# 5/8 "MANGALORE" + "MATHURA"

PROPOSED ARRANGEMENT OF SHELL + DECKS AT JUNCTION  
OF FRAMES 111 + 126 AFTER SHORTENING VESSEL BY 37'-6"

PROPOSED ALTERATIONS

S.S. "Mangalore"  
M.D.B. RPT. No. 15385

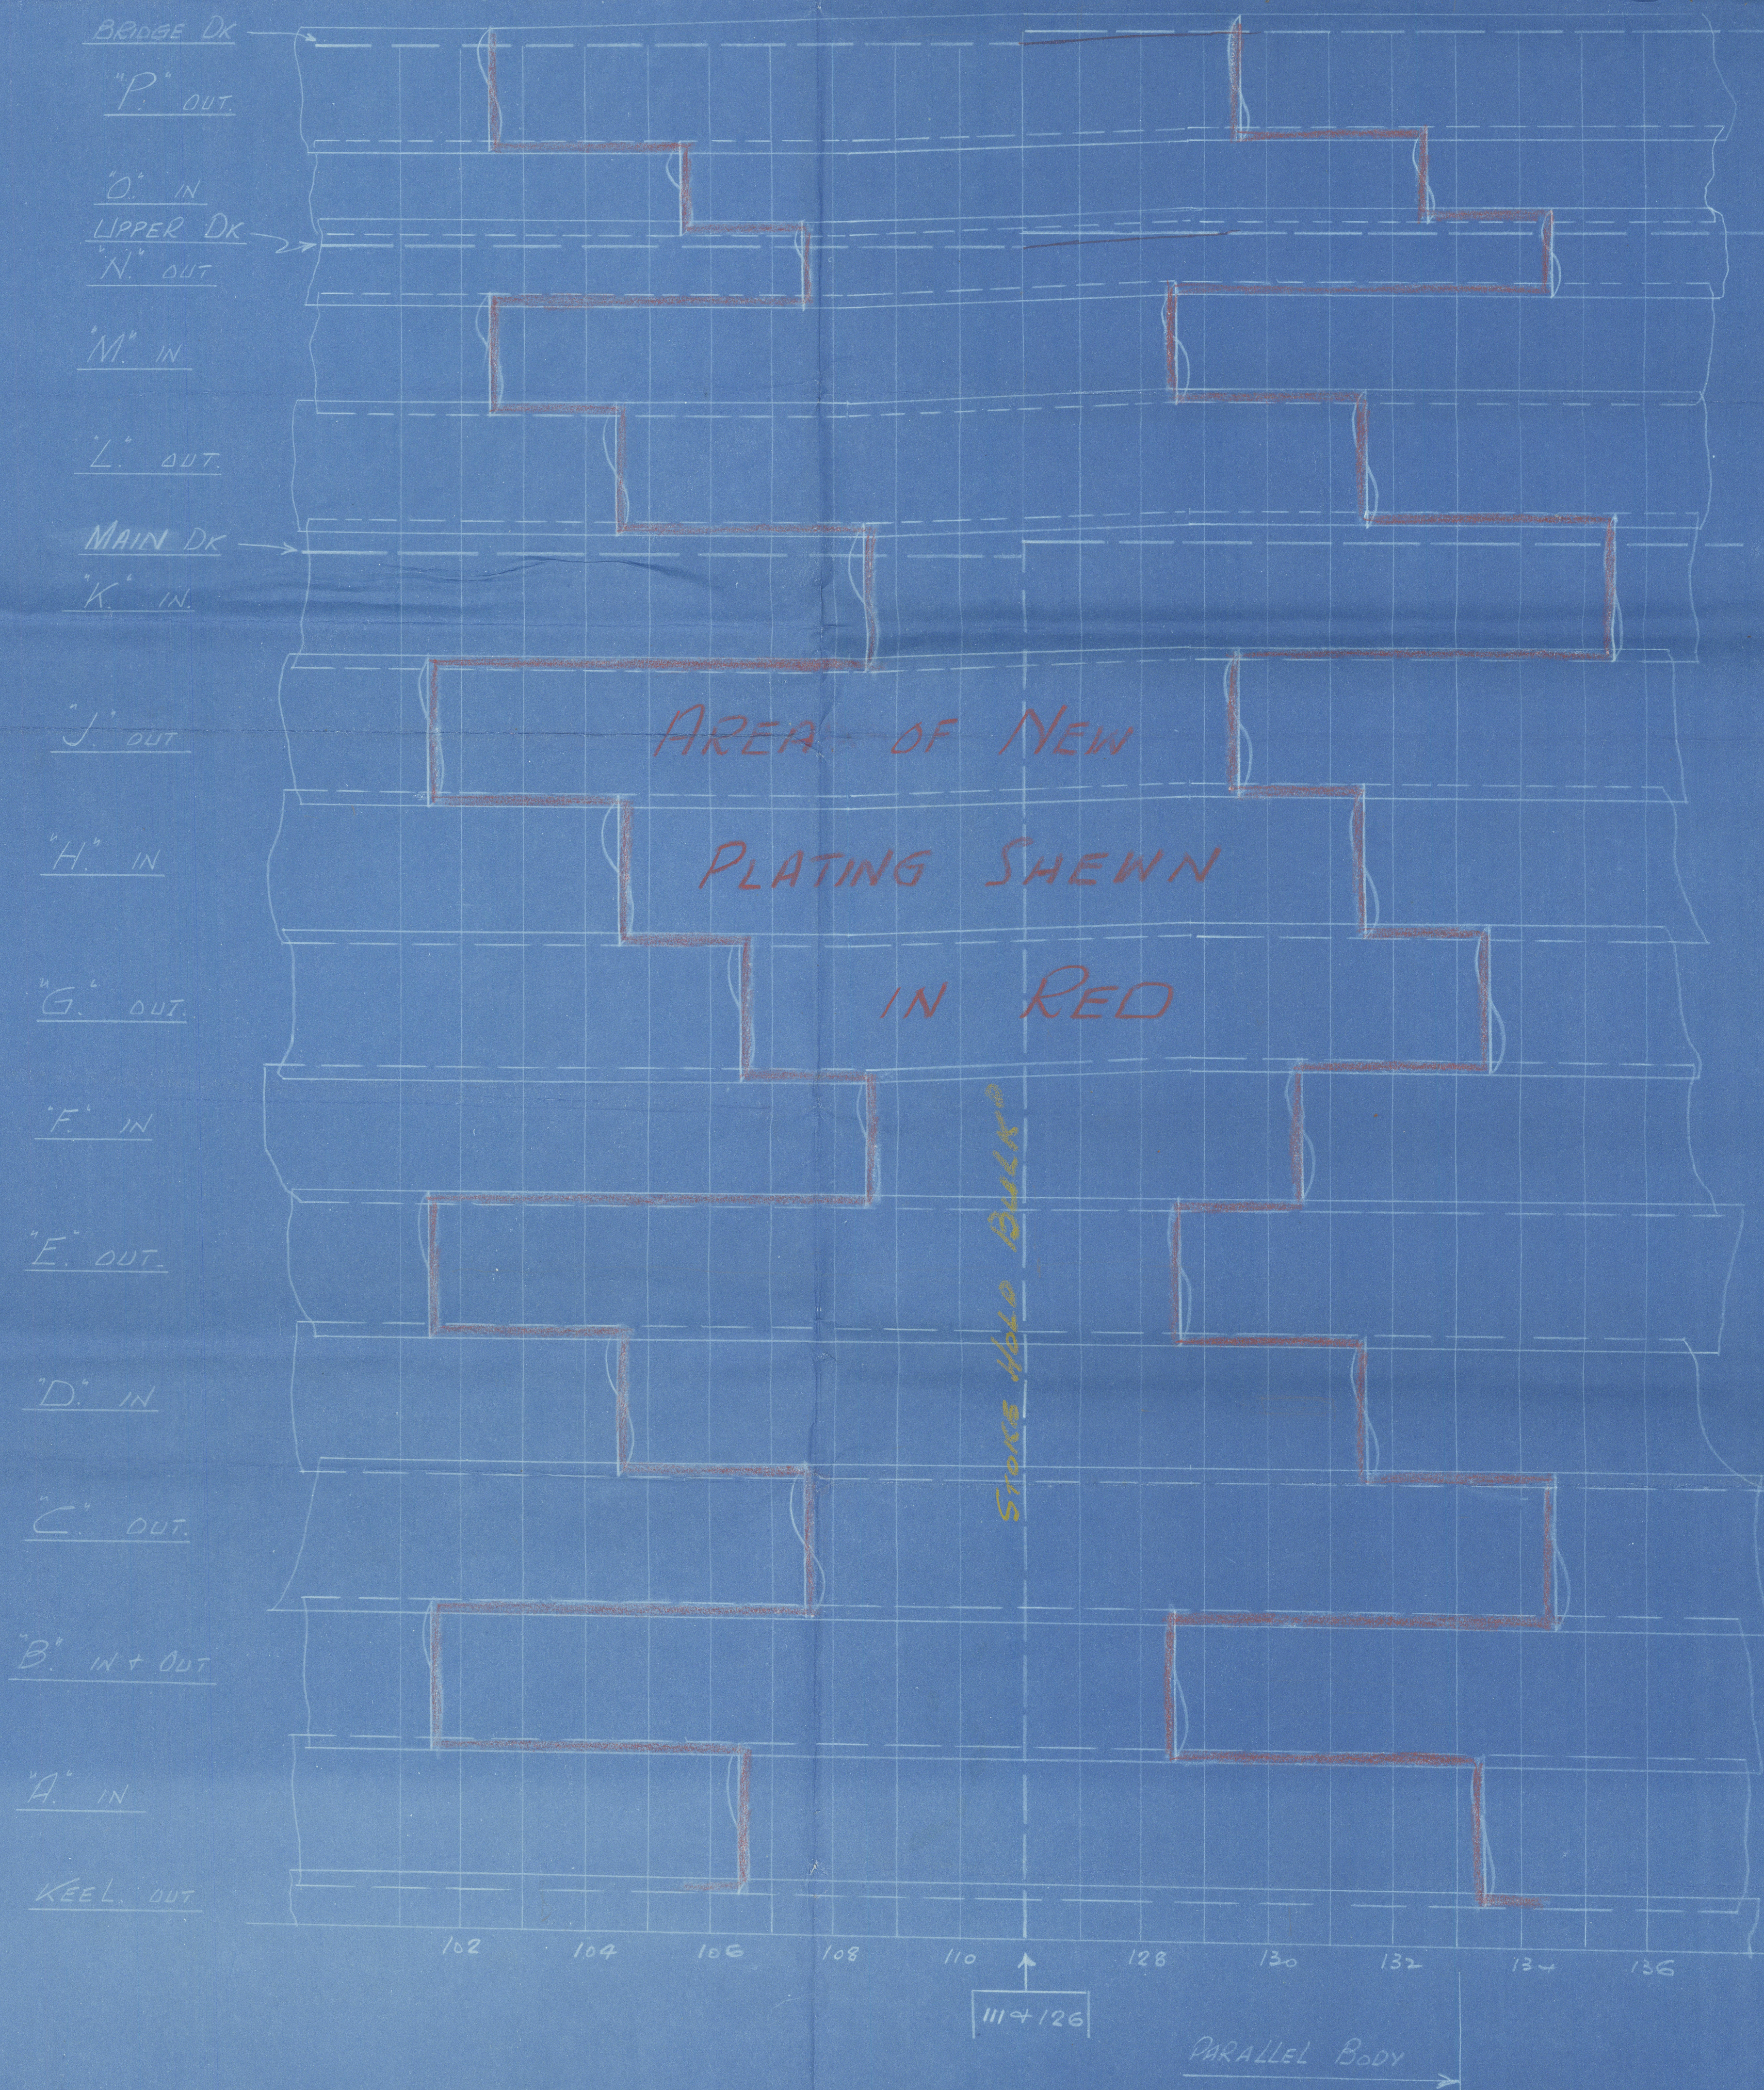
SECTIONS AT THREE DECKS AT JUNCTION  
OF FRAMES 111 + 126 AFTER SHORTENING  
SHIP. (SECTIONS ARE CLEAR OF HOUSES +  
CASINGS) DIFFERENCE IN SHEER HEIGHTS  
IS APPROX. 5/8"
